**CITY OF ALBUQUERQUE
PLANNING DEPARTMENT
September 30, 2015
DRB Comments**

PROJECT # 1010378 APPLICATION # 15-70345

RE: Lots 10A & 10B, Candelaria Plaza Addition

Plat for
Lots 10-A1, 10-B1 and 10-B2
Block A,
Candelaria Plaza Addition
 Being comprised of Lots 10-A and 10-B,
 Block A, Candelaria Plaza Addition
 Within Projected
 Section 6, T 10 N, R 3 E, NMPM, within
 the Town of Albuquerque Grant
 City of Albuquerque
 Bernalillo County, New Mexico
 July 2015

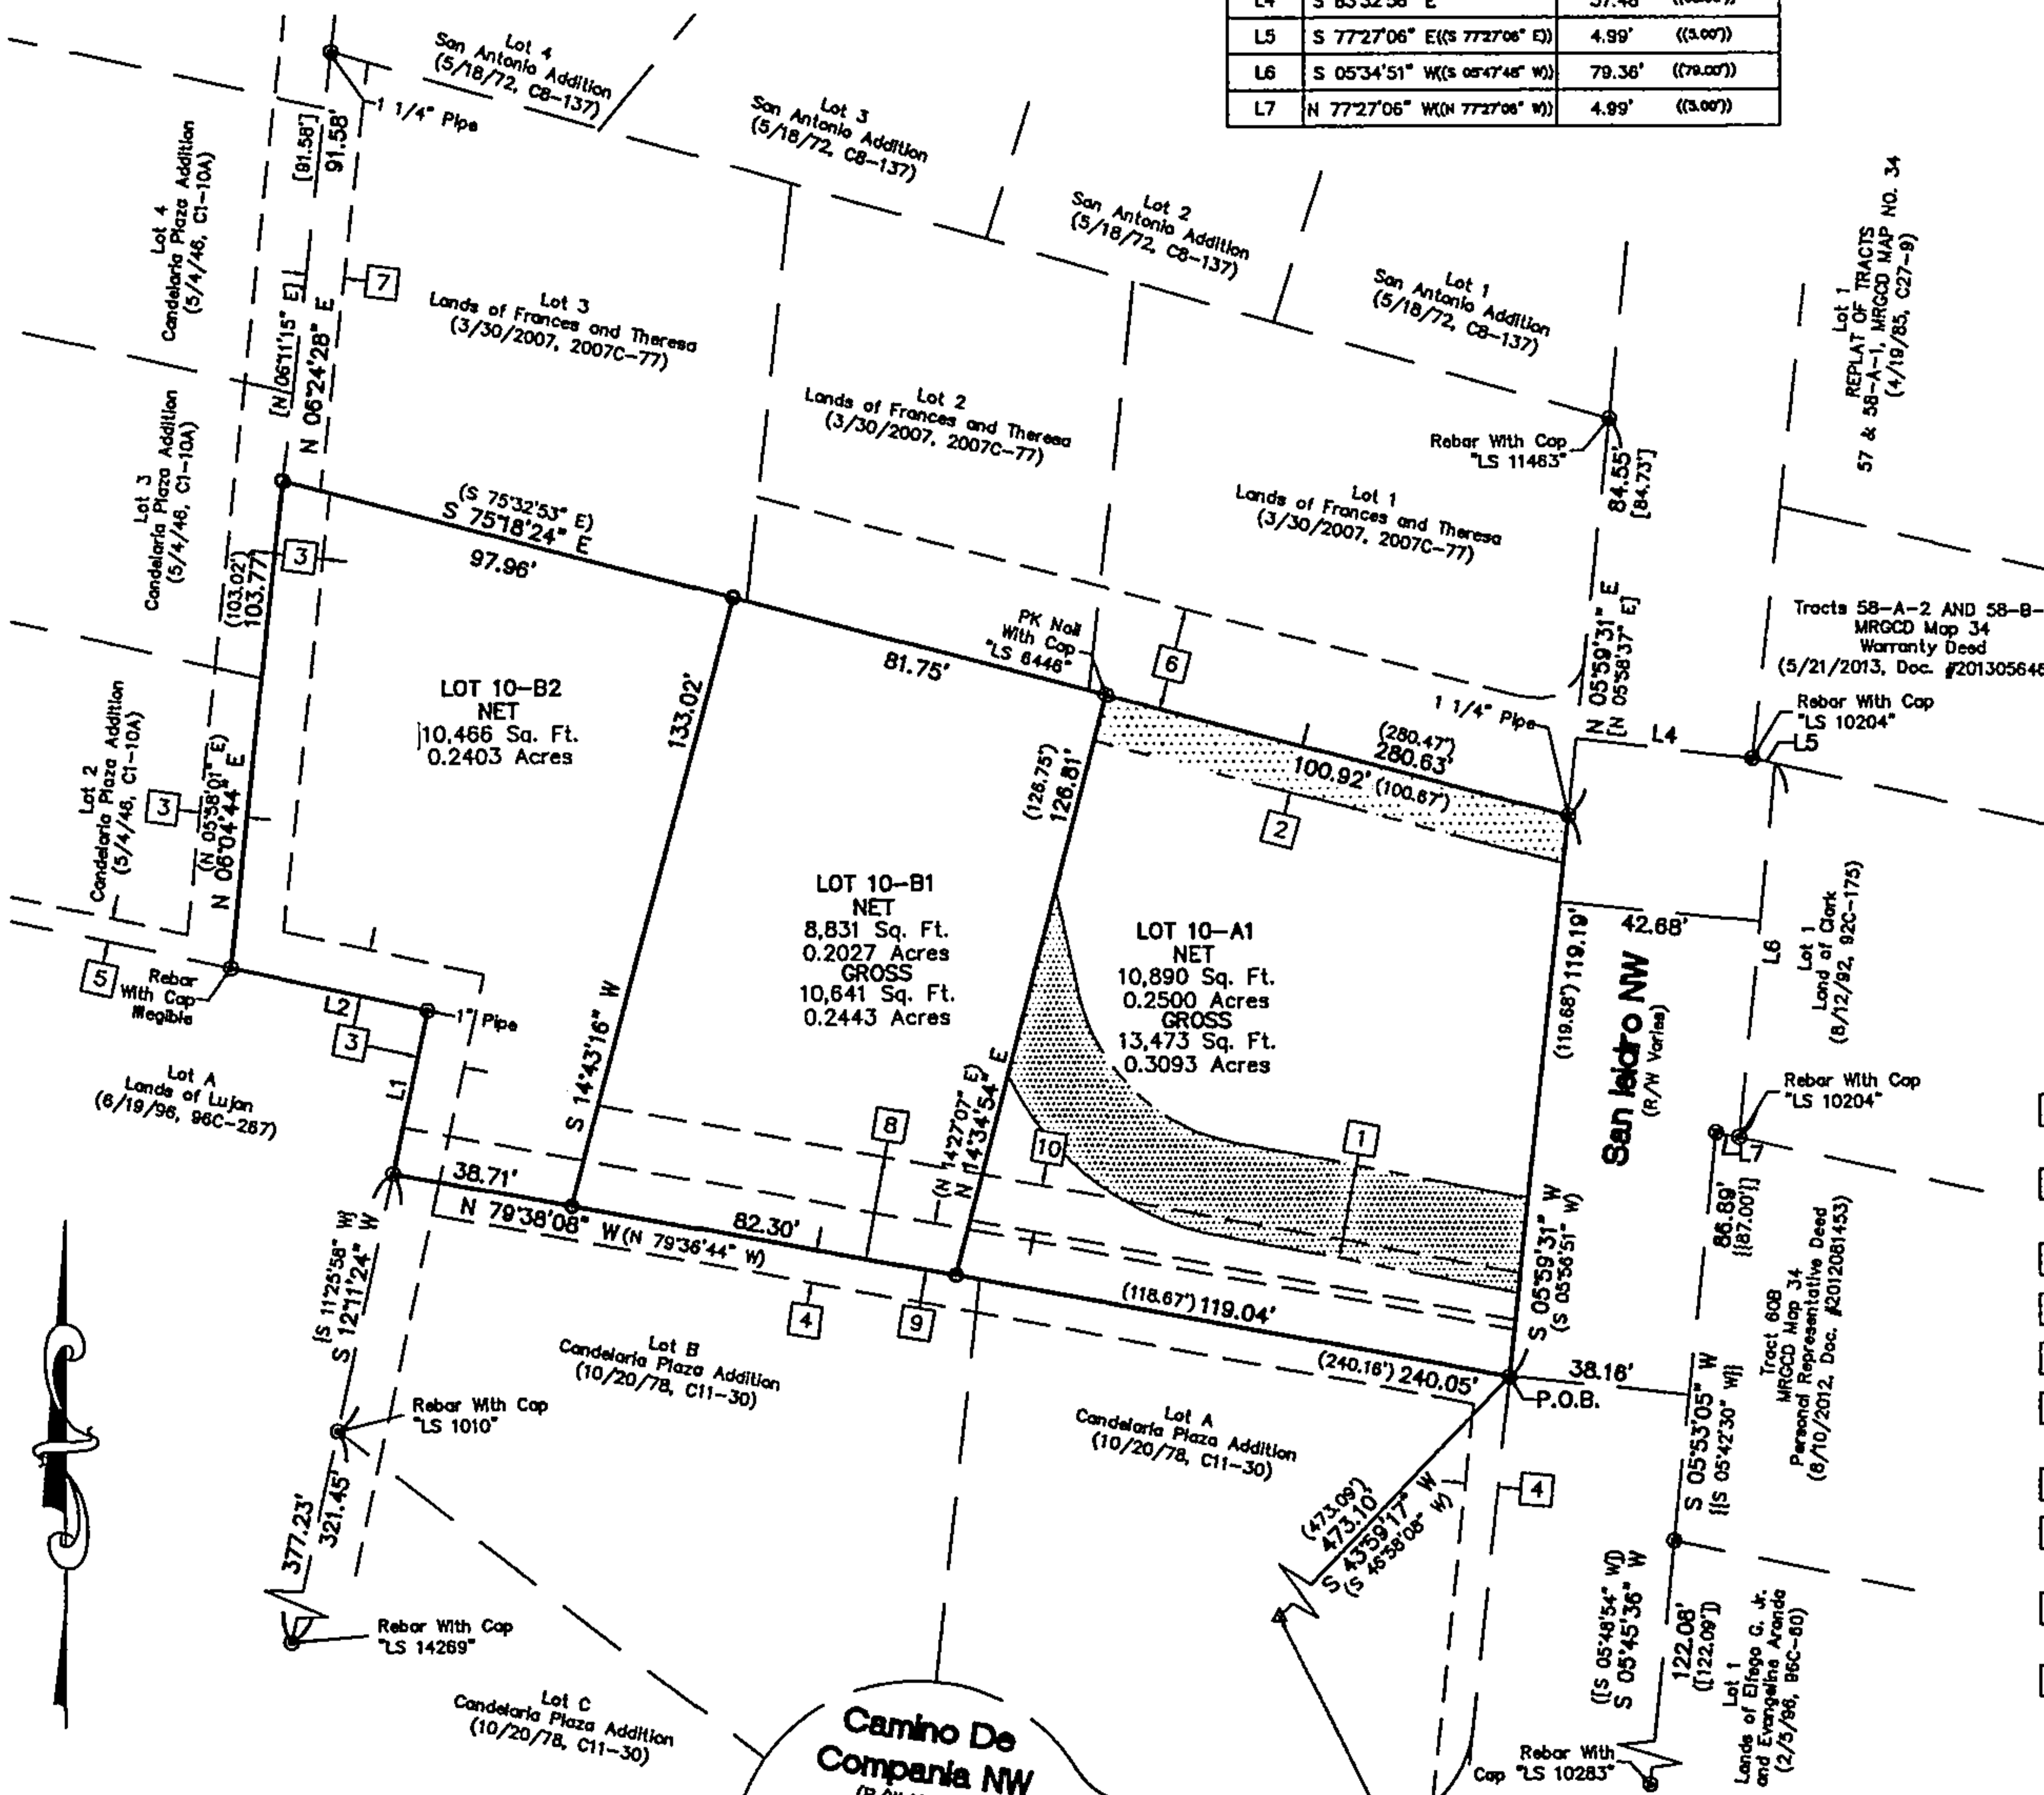
RA-2 zoning requires a minimum .25 acre Net (exclusive of access easements). A Lot Area Variance would be required for proposed lots 10 B-1 and 10 B-2, and if the Variances are specific they would need to match the proposed plat.

Minimum Access Easement width for 2-3 lots is 22 feet. Private Water and Sanitary Sewer Service Easements will be required for proposed two rear lots.

RA-2 zoning requires a minimum .25 acre *Net* (*exclusive* of Access Easements). A Lot Area Variance would be required for proposed lot 10 B-2; the Variance for proposed Lot 10 B-1 would need to be amended to allow a variance of approximately 2,044 square feet, or more if the lot line is adjusted for proposed Lot 10 B-2 to meet the minimum 10,890 square feet.

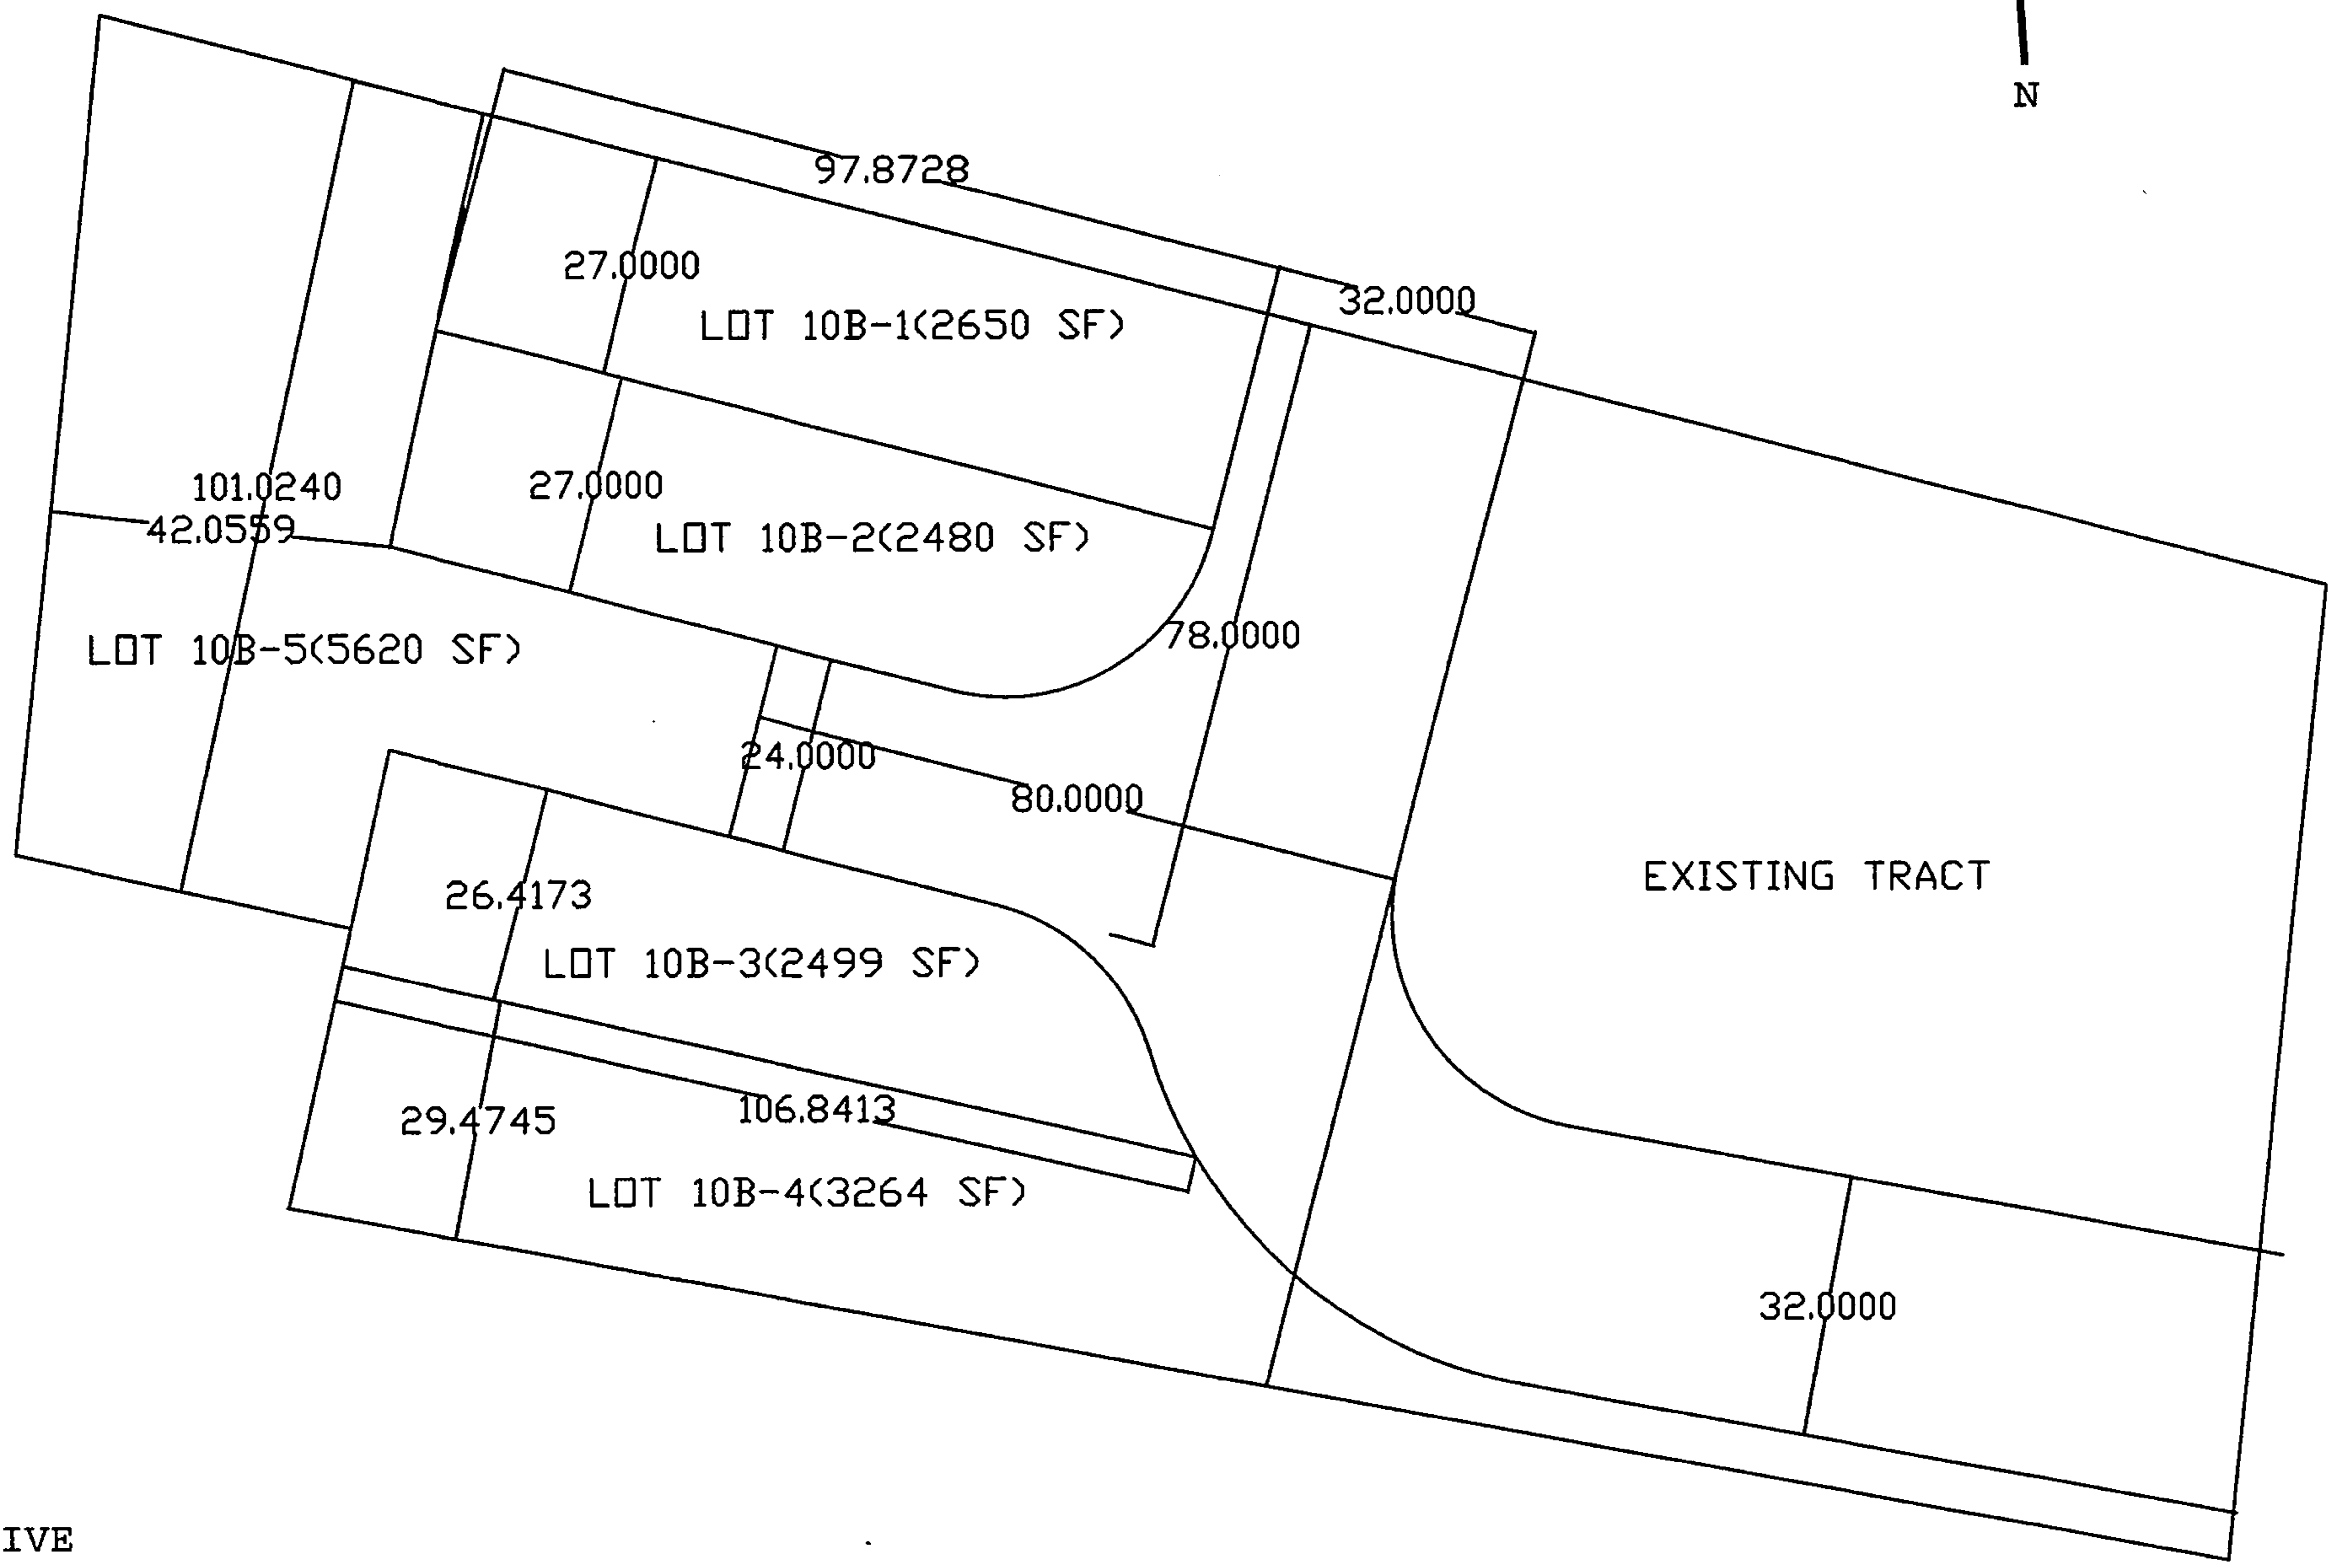
Bernalillo County Assessor data indicates a total area of .8 acre (not 3.5). Both lots would require a zone change (minimum R-1 for Lot 10A which would end up with less than 10,000 sq ft net).

Proposed access easement would need to be platted over the proposed lots, not a separate tract. Fire Marshall and Solid Waste approval (typically for individual lot front pickup) would be required. It appears Subdivision Design Variance(s) would be required for San Isidro, and may be applicable for proposed access – refer to comments from Transportation Development. Individual drivepad locations may need to be identified.
